**MONTGOMERY COUNTY HISTORIC PRESERVATION COMMISSION**  
**STAFF REPORT**

<b>Address:</b>	8 Quincy St., Chevy Chase	<b>Meeting Date:</b>	7/10/2019
<b>Resource:</b>	Contributing Resource Chevy Chase Village Historic District	<b>Report Date:</b>	7/3/2019
<b>Applicant:</b>	James Cassidy	<b>Public Notice:</b>	6/26/2019
<b>Review:</b>	HAWP	<b>Tax Credit:</b>	N/A
<b>Case Number:</b>	35/13-19BB	<b>Staff:</b>	Dan Bruechert
<b>Proposal:</b>	Demolition and New Construction

**STAFF RECOMMENDATION**

Staff recommends that the HPC **approve** the HAWP application.

*Figure 1: A non-historic addition connects the garage to the historic house.*

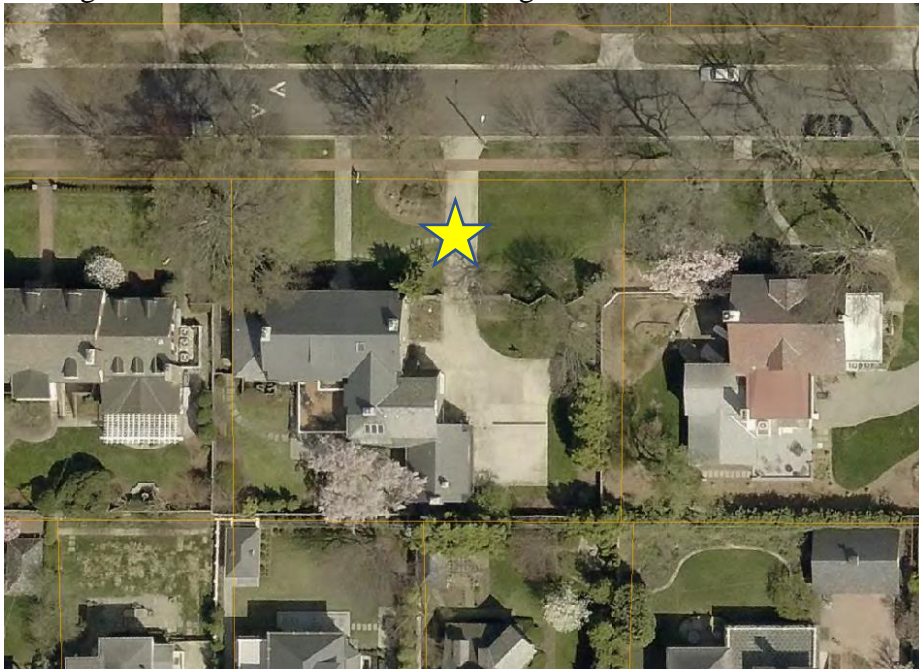
The existing rear building addition is two stories tall with an exposed basement and has a side gambrel that projects beyond the existing historic wall plane. This addition was constructed c.1991 and was likely permitted before the establishment of the Chevy Chase Historic District. The applicant proposes to demolish the existing addition. This addition is not historic and while the form is compatible with the historic house, it does not contribute to the historic character of the house or surrounding district. Staff supports approval of the demolition under 24A-8(b)(2).

In place of the existing addition, the applicant proposes to construct a new, full-width addition to the rear. In place of the side-projecting, two story, gambrel, the applicant proposes to construct a one-story, sunroom with a hipped, copper roof. The exposed basement level of this addition will be clad in stone veneer to match the appearance of the historic house. The side projecting addition is being built over the existing foundation and will not expand beyond the existing construction. The new addition will also allow more of the garage roof to be visible from the public right-of-way, providing a visual separation between the house and garage roof lines. Staff finds that the new design will have less visual impact than the existing two-story construction, and is compatible in size, scale, massing, and materials with the existing building. Staff additionally finds the use of a copper roof consistent with the district *Design Guidelines* policy of promoting architectural excellence.

Staff finds that the proposed rear addition demolition and new rear addition are consistent with the *Design Guidelines*, Standards 9 and 10, and 24A-8(b)(2) and recommends approval.

Figure 2: 8 Quincy St. had a side porch addition by 1927.

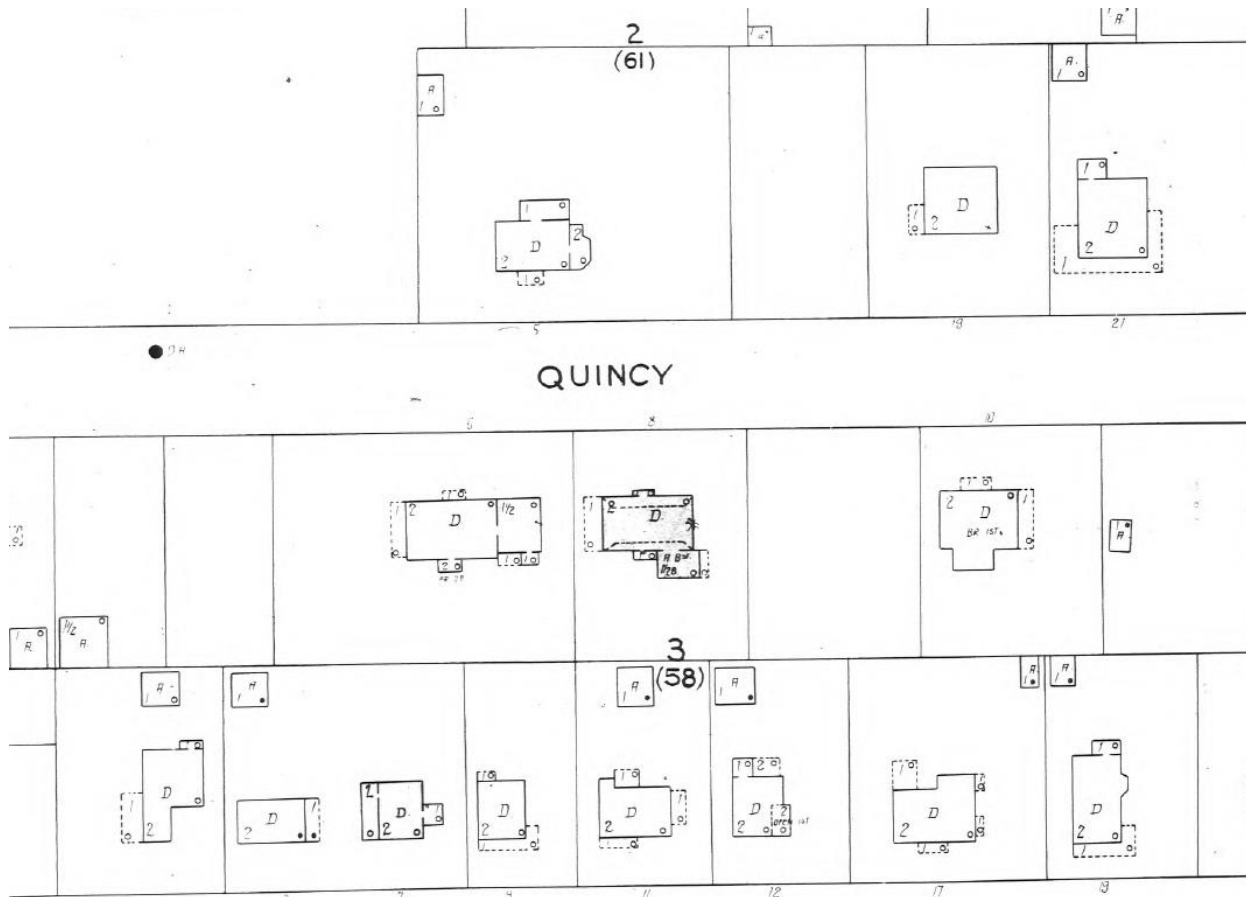
On the right (west) side of the house there is a one-story porch. Based on the placement, materials and the Sanborn map, it appears as though this porch is a historic feature of the house.

At some point, the porch was filled in with six-over-six sash windows with solid panels below. The applicant proposes to remove the existing windows and panels and to install a new wood guardrail, in a Chippendale pattern, and install screens above. Porches that are visible from the public right-of-way are to be reviewed under “moderate scrutiny.” Staff finds that the proposed treatment of the side porch is appropriate and will not impact the integrity of the historic house. Staff additionally, finds the materials to be consistent with a historic side porch and the house. Staff recommends approval of the porch reconfiguration as being consistent with the *Design Guidelines* and 24A-8(b)(2) and recommends approval.

Garage Door  
Specification

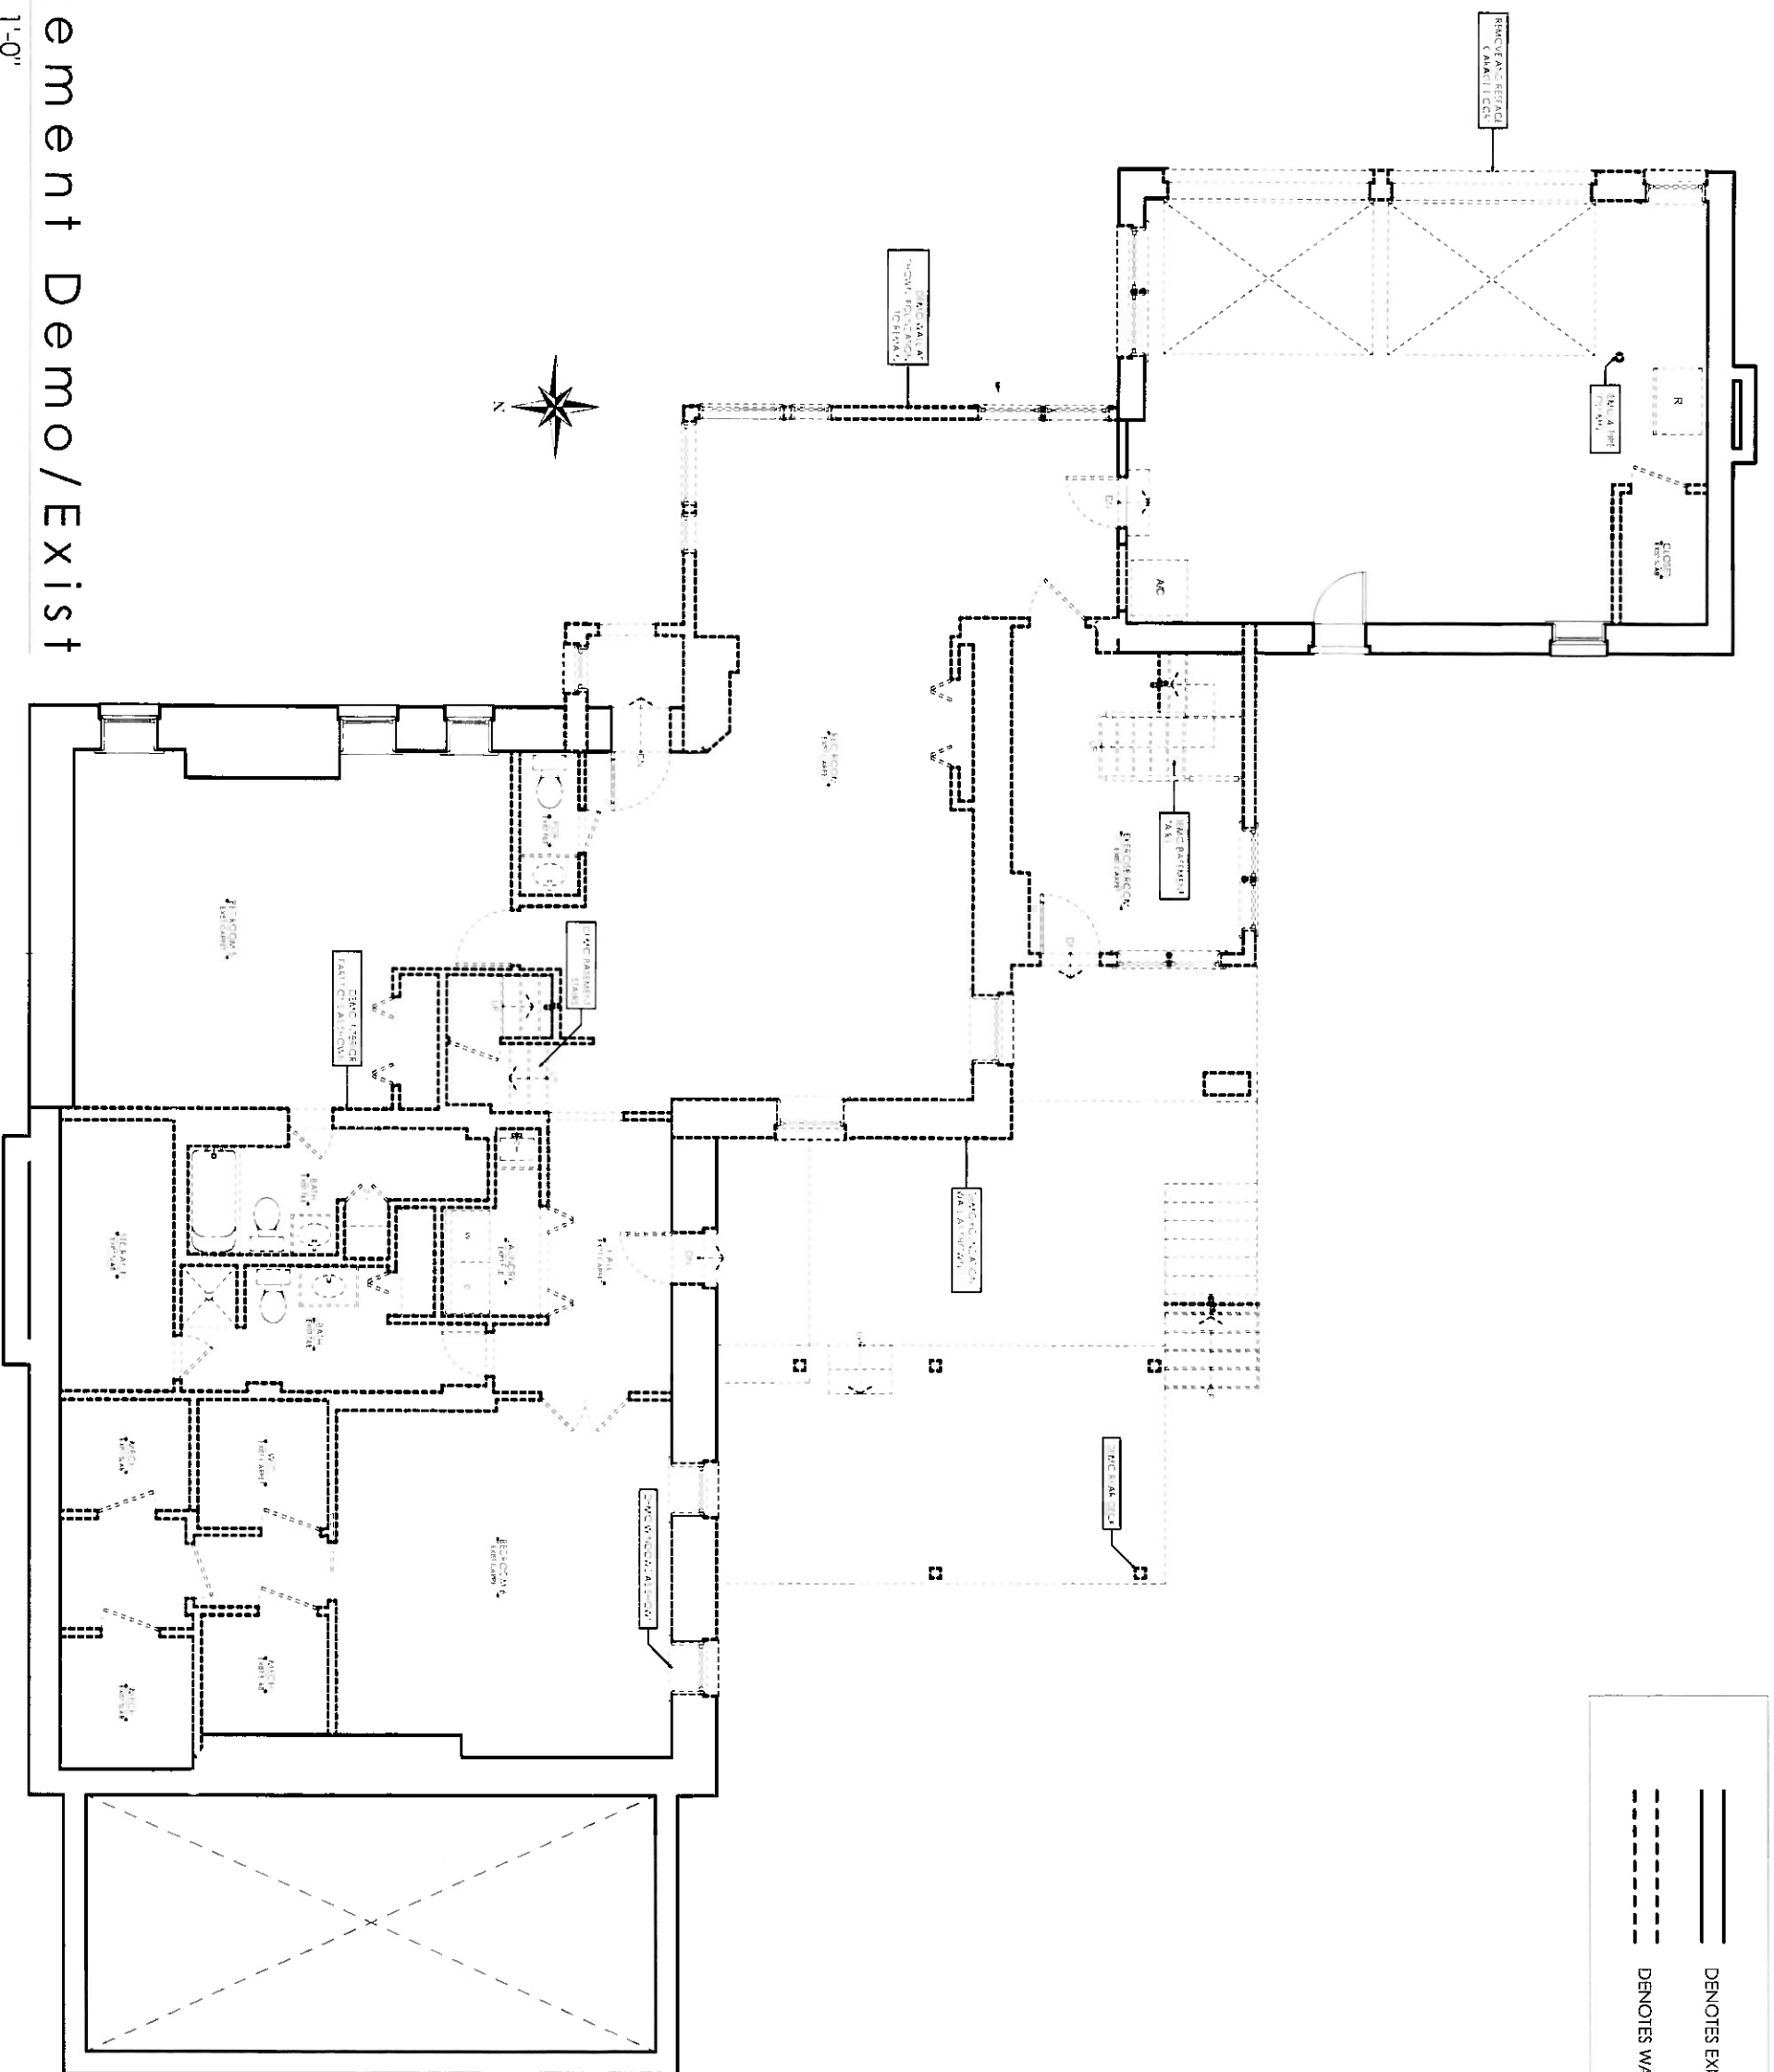
Finally, the applicant proposes to remove the existing garage doors and install new doors in new openings and to install new windows. As the garage is attached to the house, and will remain attached under the work proposed, these changes are to be reviewed under “Moderate Scrutiny.” The existing garage doors are roll-up wood or fiberglass doors facing east. The doors are not historic, and their removal will not impact the historic character of the property. The applicant proposes to remove the first-floor sash window, and re-center the two garage doors and install two new, wood, carriage-style doors. Details and specifications for the proposed doors is included on page T7 of the application materials. Staff finds that the alteration proposed will reconfigure the openings of the garage, but finds that the location is sufficiently removed from the streetscape so as not to have a significant impact on the historic character of the garage. Additionally, Staff finds that even with the alteration, the garage still contributes to the character

of the house. The simply detailed doors are compatible in both design and material, per the *Design Guidelines*, and Staff recommends approval.
